**PLANNED UNIT DEVELOPMENT
& SUBDIVISION STAFF REPORT****Date: August 20, 2020****DEVELOPMENT NAME**

Rangeline Crossing

Resubdivision of Lot 2, Rangeline Crossing Subdivision III

LOCATION5000 Rangeline Crossing Drive
(Southeast corner of Halls Mill Road and Rangeline
Crossing Drive [private drive]).**CITY COUNCIL
DISTRICT**

SITE PLAN

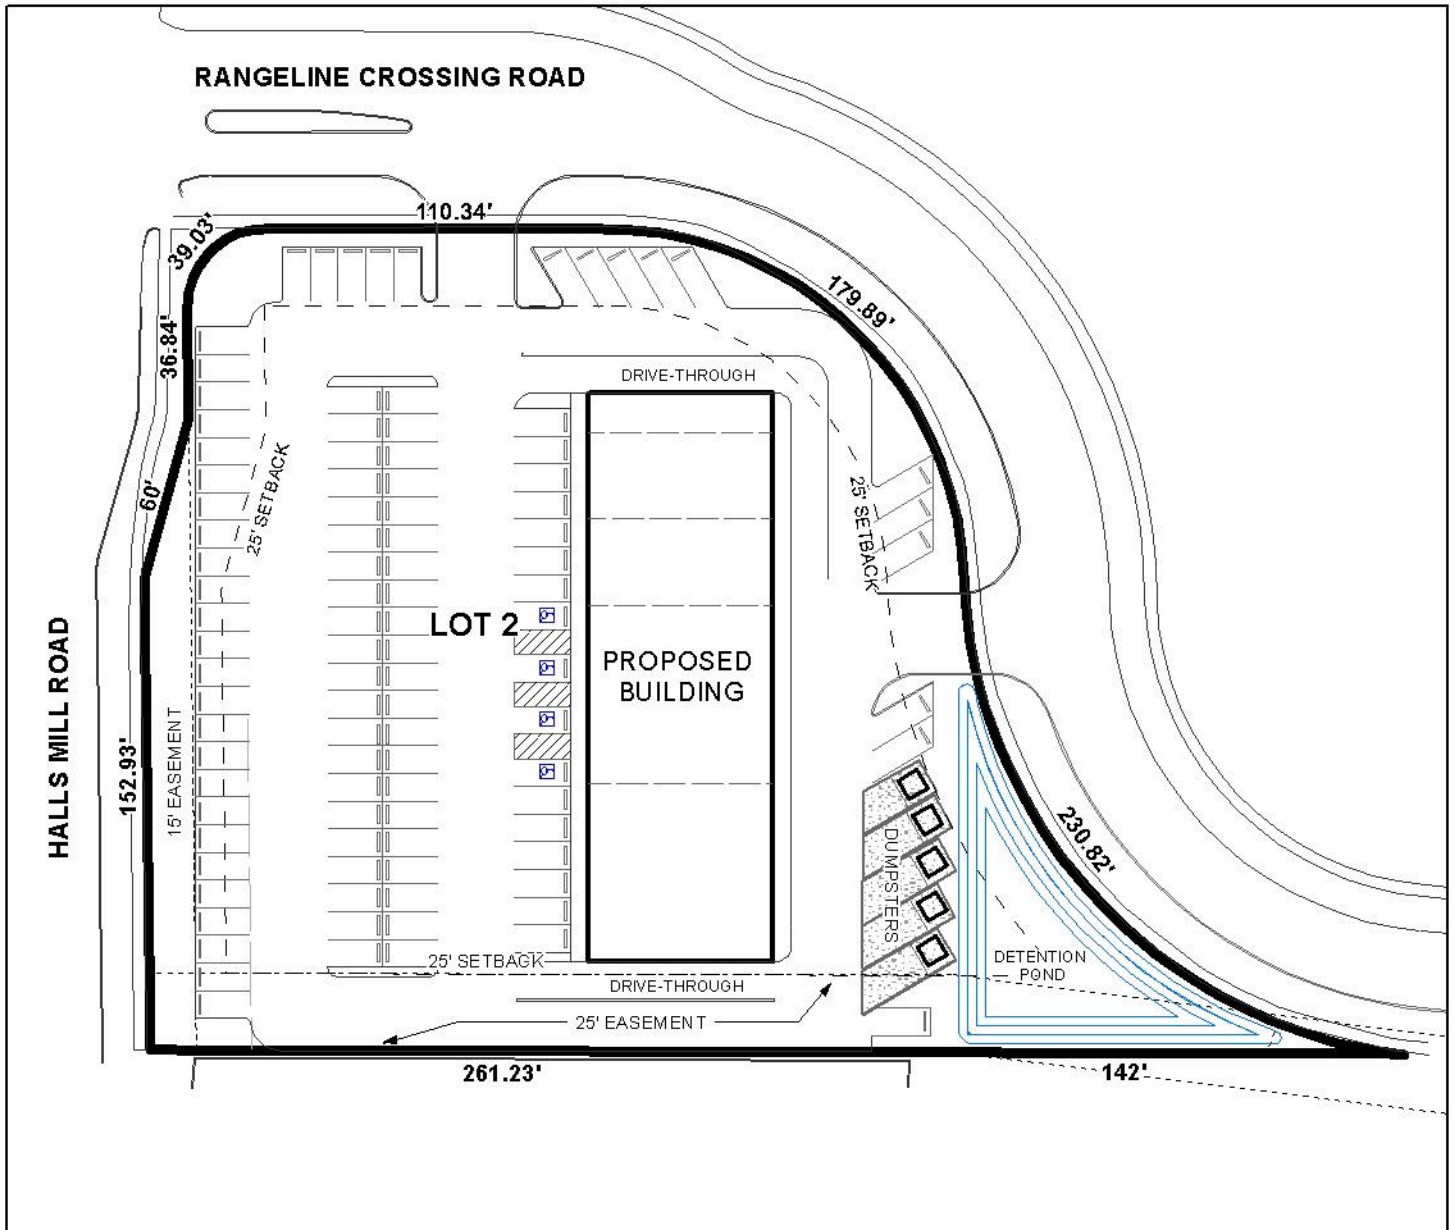
Order stations for the drive-thru facilities are not indicated on the PUD site plan, thus it is not clear if the drive-thru facilities comply with the above-noted criteria for queuing spaces. The site plan should be revised to depict full compliance with these criteria.

Five individual dumpsters with enclosures are depicted on the site plan, to serve the five proposed tenant spaces. It appears that the placement and access will comply with Section 64-4.D.9. of the Zoning Ordinance, however, the applicant should ensure that requirements of this section are met.

Per the notes provided on the site plan, the site will comply with the overall and frontage landscape area requirements of Section 64-4.E. of the Zoning Ordinance. Tree compliance is not depicted on the site plan, however, the site will require 26 overstory frontage trees, 8 perimeter trees, and 5 parking trees, for a total of 39 trees on site, of which 30 must be overstory trees. A compliant landscape plan is required at the time of application for land disturbance.

Freestanding signage is not depicted on the site plan. The applicant should take tree and landscape requirements into consideration when locating any freestanding signage on the site.

- 9) Provision of a revised PUD site plan reflecting any conditions of approval;
- 10) Completion of the Subdivision process prior to any request for Certificates of Occupancy; and
